**Iowa Department of Transportation**  
 Highway Division

STANDARD DESIGN - 40' ROADWAY, THREE SPAN BRIDGE

**PRETENSIONED PRESTRESSED CONCRETE BEAM BRIDGES**

<b>LONGITUDINAL SECTION</b> 15° SKEW C BEAMS	<b>H40-14-06</b>
---	------------------

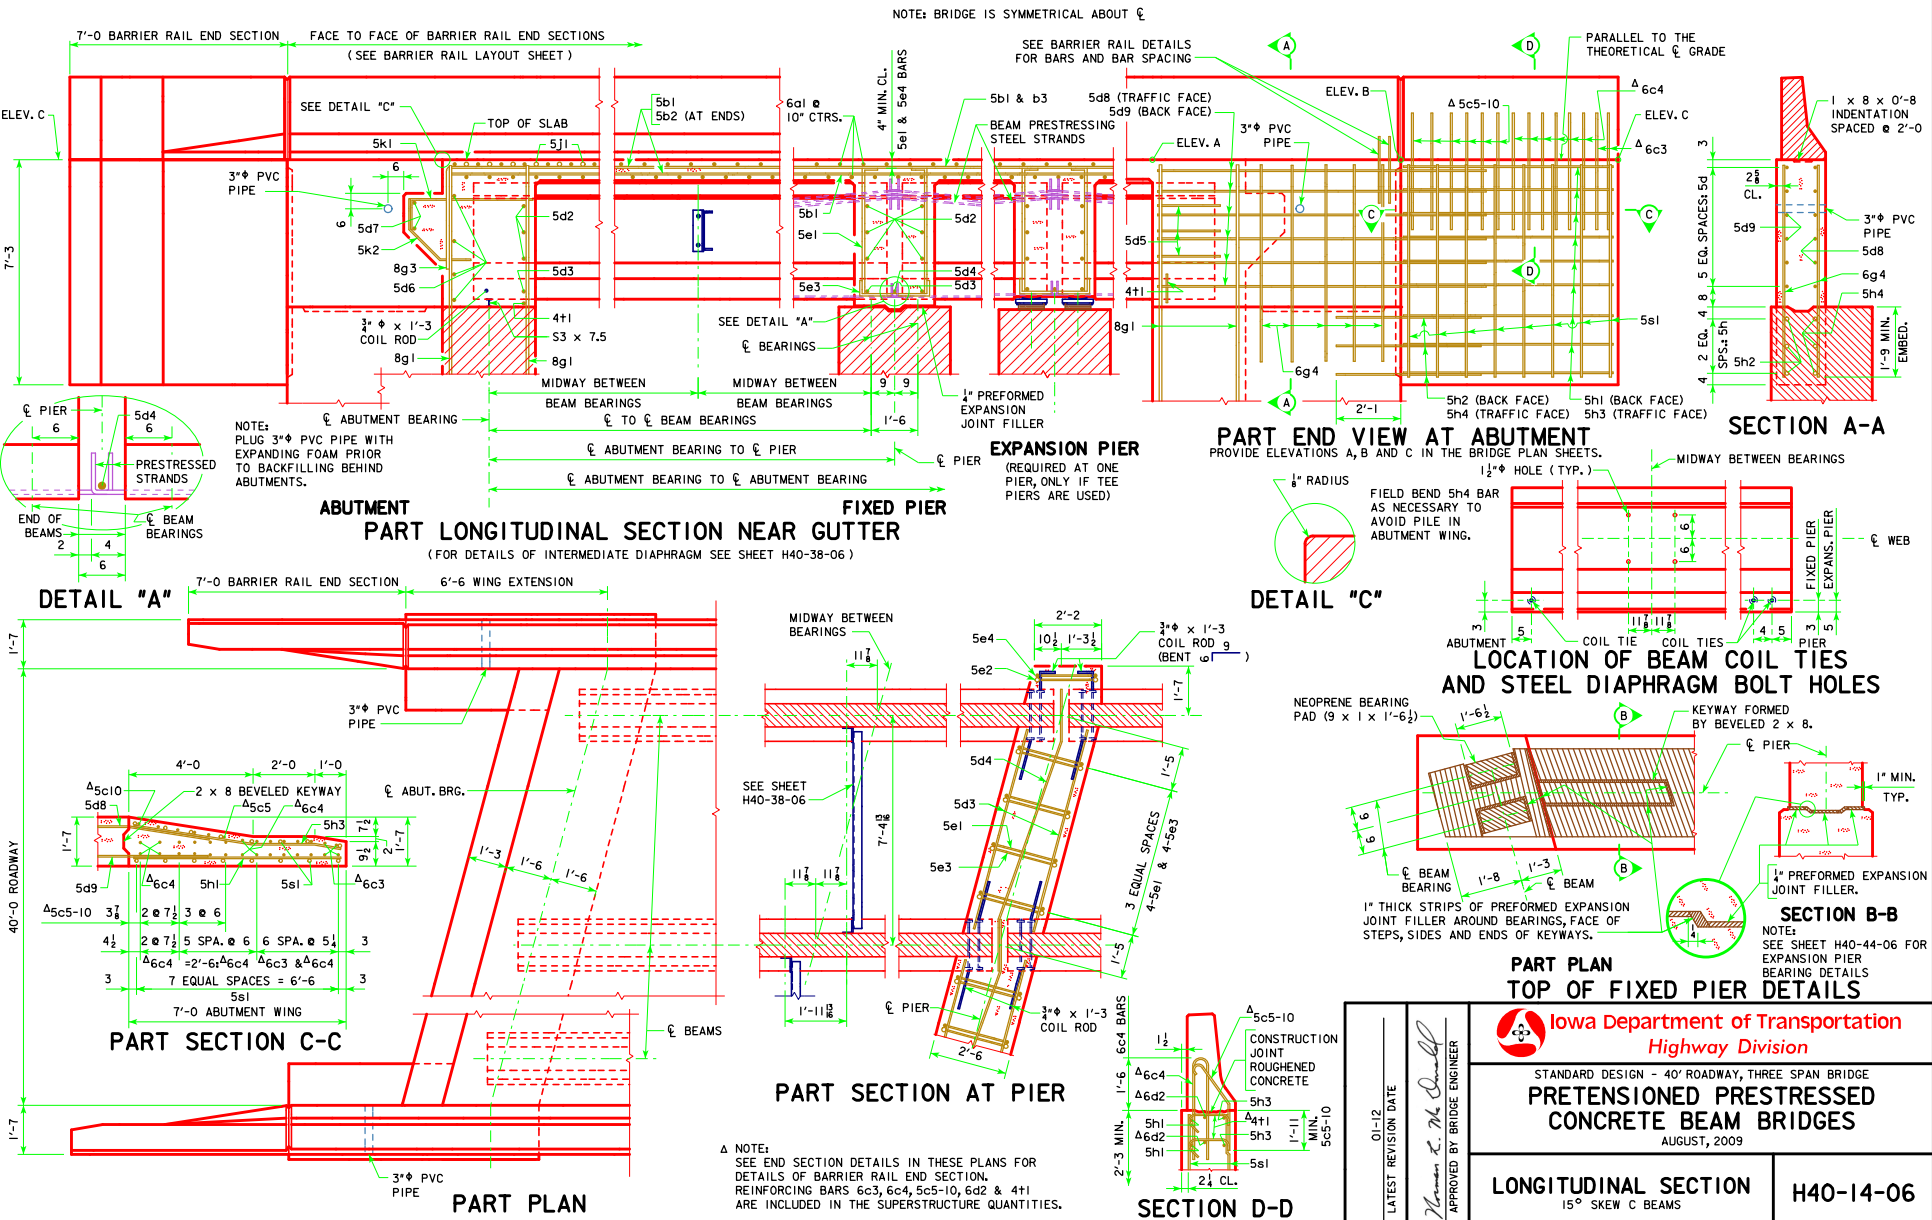
REVISED 01-12 - ADDED FIELD BEND 5h4 BAR TO AVOID PILE IN ABUTMENT WING NOTE.
